RESPONSE TO SUBMISSIONS HORSLEY LOGISTICS PARK

State Significant Development
Application (SSD-10436)

Prepared for
ESR AUSTRALIA
November 2020

Figure 6 Southern Boundary Landscaped Setbacks

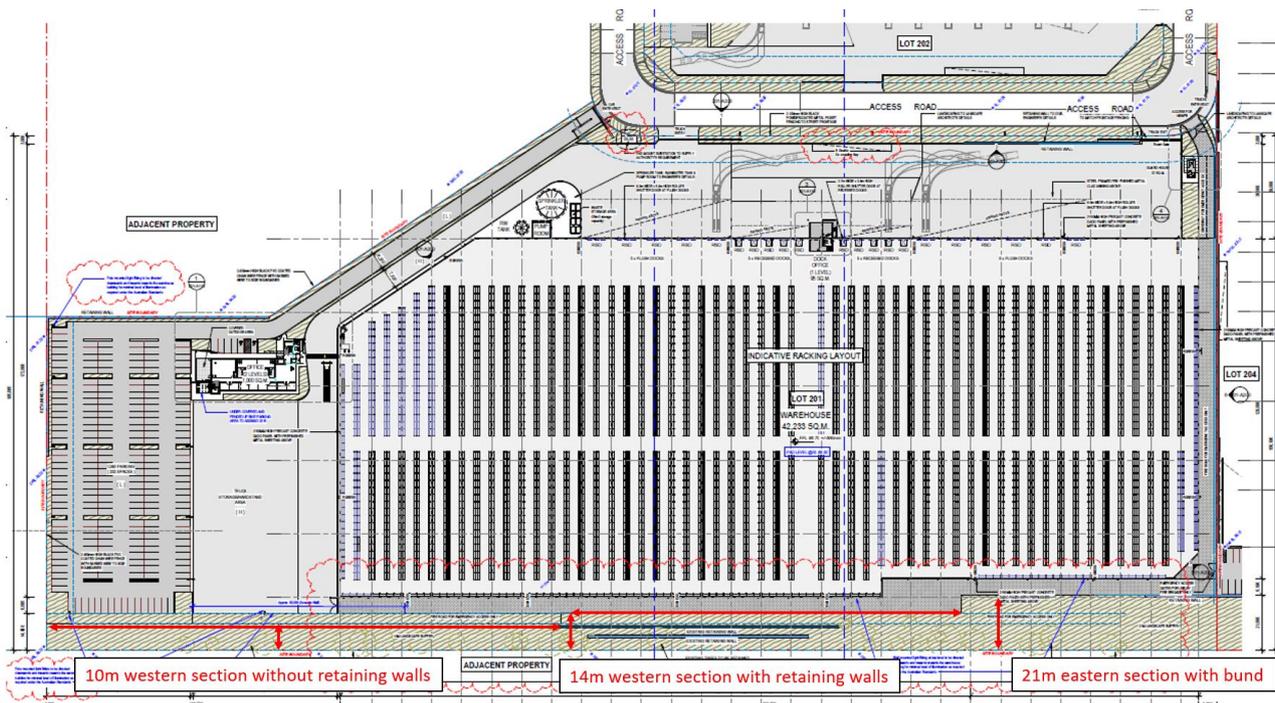
The total floor area of the warehouse on Lot 201 reflected in the body of the EIS does not appear to reflect the floor plans submitted. The total gross floor area (GFA) of the warehouse has been calculated by the Department as 44,538 m² including 1,095 m² of offices.

Figure 6 below illustrates the amended southern boundary condition and the updated Lot 201 layout plan.

As detailed in **Section 2.4** of this RtS, minor amendments to the southern landscape boundary has resulted in the reduction of gross floor area of the warehouse area on Lot 201 from 43,488m² proposed in the EIS compared to 42,233m² proposed in this RtS (-1,255m²). No change is proposed to the office space area which totals 1,095m² (main office and dock office) and 22m² for the guard house.

Figure 8 Approved Subdivision Layout – DA 893.7/2013

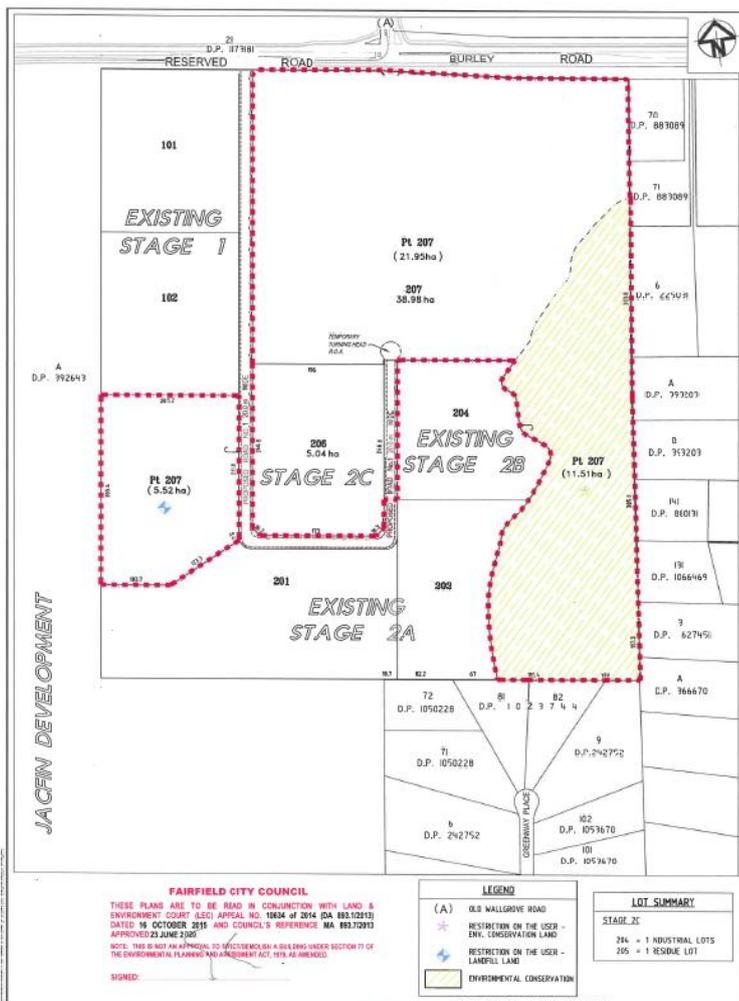
Provide further details and plans associated with the two modification applications to DA 893/2013 presently under assessment with Fairfield City Council (Council). Also provide a status of these modification applications.

Response: DA 893.7/2013 was approved by Fairfield City Council on 23 June 2020. This amended the subdivision layout of the site.

The approved subdivision plans are provided at **Appendix L** and **Figure 8** for reference. The approved lot layout is reflected in the subject proposal.

Figure 9 2020 RAP Site Plan

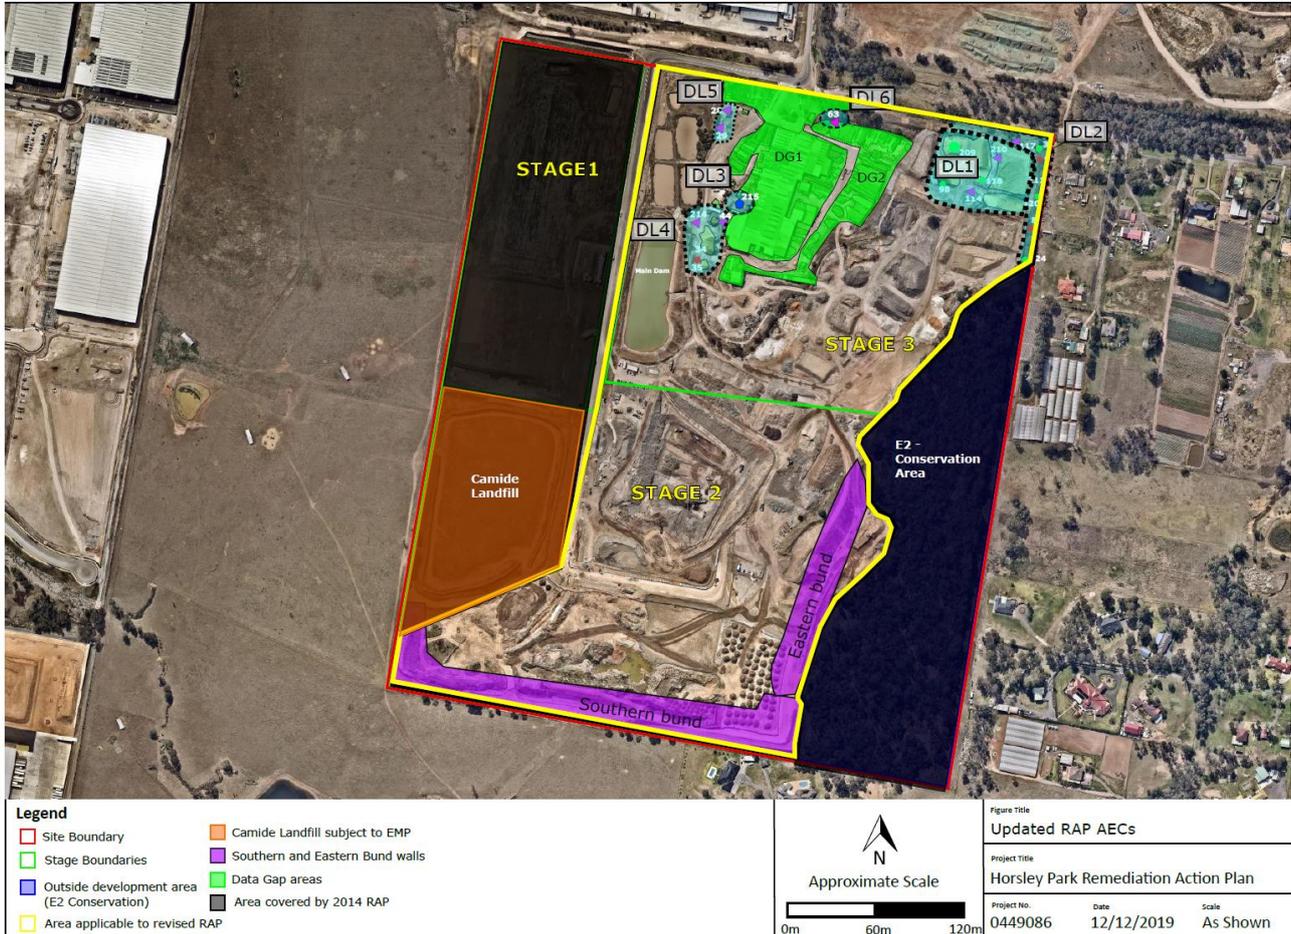
Provide the Remedial Action Plan and contamination assessments submitted with DA 21/2020 under assessment with Council.

DA 21/2020 relates to Lot 2 DP 1228114 which is the future Stage 3 of the CSR Estate. It specifically relates to the approved Lot 306 DA 893.1/2013 (as amended) which sits outside the boundary of, and to the north of the HLP boundary.

Figure 11 Noise and Vibration Impact Assessment Site Plan

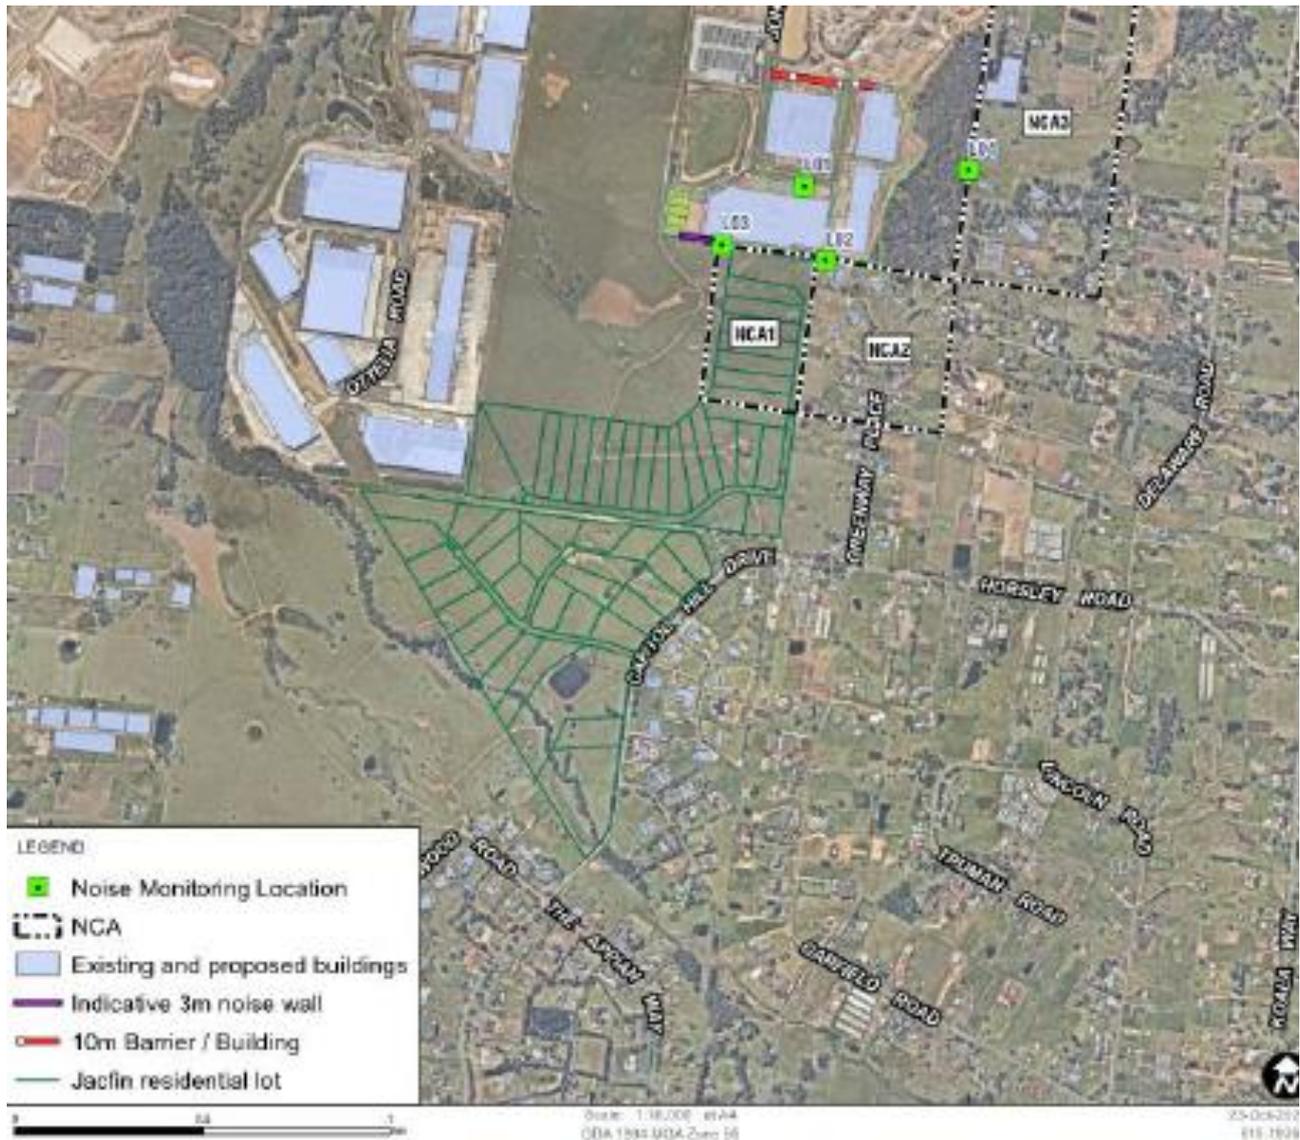
The noise contour figures in the Noise and Vibration Assessment (NVA) do not reflect the site layout plans submitted with the EIS. In particular, the warehouse on Lot 202 does not match the submitted plans. Clarification of this issue is required.

These figures provided within the body of the Noise and Vibration Assessment (NVA) are for illustrative purposes and are not what was assessed for noise impact purposes. Notwithstanding this, the noise contour figures have been amended to reflect the correct Lot 202 site layout and amended Lot 204 layout, as demonstrated in the Figure 3 of the NVA at **Appendix D** and **Figure 11**.
